MEMORANDUM

REVIEW TYPE: Pre-Preliminary Plan of Subdivision (**Binding Conditions**)
Pursuant to Section 50-33A

APPLYING FOR: Resubdivision of Existing Lot 38, Bowie Mills Estates
Subdivision for Two Lots

PROJECT NAME: Bowie Mill Estates
CASE #: 720060250
REVIEW BASIS: Chapter 50, Montgomery County Subdivision Regulations

5615 FOGGY LANE
PROPOSED LOTS 39 - 40
BOWIE MILL ESTATES
NEIGHBORHOOD MAP

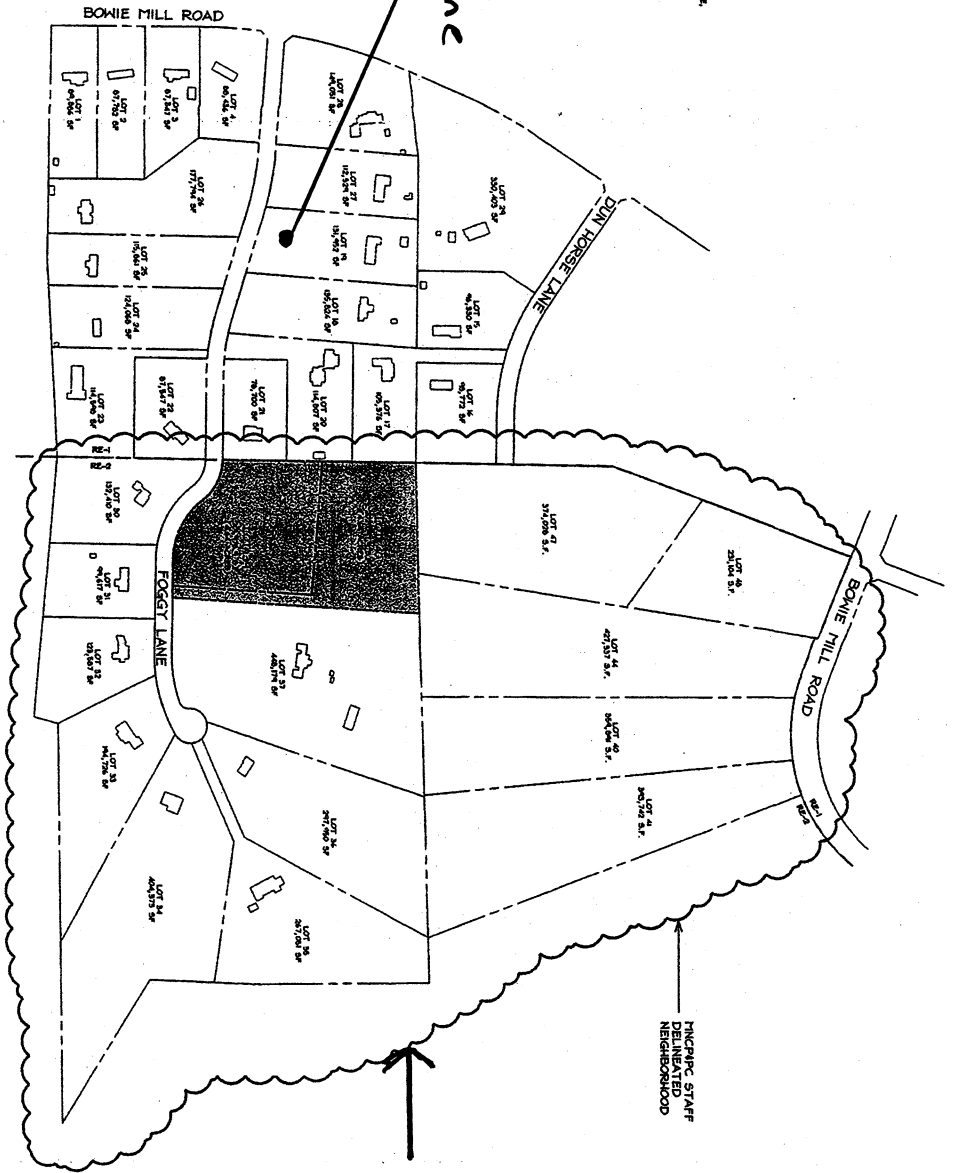
In administering Section 50-29(b)(2) of the Subdivision Regulations, the Planning Board must determine the appropriate "Neighborhood" to evaluate the application. For this application, the applicant submitted a Neighborhood of 32 lots that includes all lots that abut or confront the proposed lots and all lots fronting Foggy Lane as well as those in close proximity that front on Bowie Mill Road and Dun Horse Lane (**Attachment D**). This Neighborhood includes lots in the RE-1 zone; the Subject Property is zoned RE-2. Staff and the Planning Board have historically not crossed zoning boundaries when determining the Neighborhood suitable for a resubdivision evaluation. Therefore, staff asked the applicant to include only those lots in the immediate neighborhood that are zoned RE-2.

In Staff's opinion, the Applicant's proposed Neighborhood cannot be justified. Although the lots in the Applicant's Neighborhood do front on the main vehicular access route to the Subject Property, approximately half were developed under the RE-1 standards. This, and rather successful septic percolation results for those lots, has resulted in a distinct difference in lot character between the zoning boundaries on Foggy Lane and Dun Horse Lane. Therefore, staff maintains that when an adequate number of like-zoned lots are available to make a reasonable resubdivision comparison, one should exclude lots of another zoning category, based in part on the unique characteristics that each zoning category can impart upon a given subdivision. The Neighborhood that staff used for analysis includes the 13 lots in the RE-2 zone, and staff is of the opinion that it is the appropriate Neighborhood for this application (Attachment C).

Please find attached (4) copies of the revised Neighborhood Map along with the respective Lot Data Tables. At your request we have added the few properties to the north. However, we respectfully disagree with your request to exclude the properties to the west. While we understand that staff would prefer not to include properties located in different zones, in this case, we find it absolutely appropriate to include those properties which immediately adjoin the subject property. As you know the subject property is zoned RE-2 and those properties to the west and bordering the subject site are zoned RE-1. It is important to realize that while they may be zoned RE-1, they are all much greater in size than the minimum 40,000 square feet permitted in that zone. In fact the smallest of these lots is 1.8 acres in size. It is also important to realize that our proposal is for only two lots which are each 4.64 acres in size, much larger than most in the RE-2 zone, and consistent with the density and the character of the neighborhood. Typically neighborhoods have been determined by those lots which are visible upon approaching the subject property. In this particular situation, the subject property is located on a cul-de-sac, therefore when arriving at or departing from the said property one would pass those RE-1 zoned lots. It is reasonable to assume that those properties that front along Foggy Lane all use the cul-de-sac, whether while walking or for parking and turn-a-round by guests.
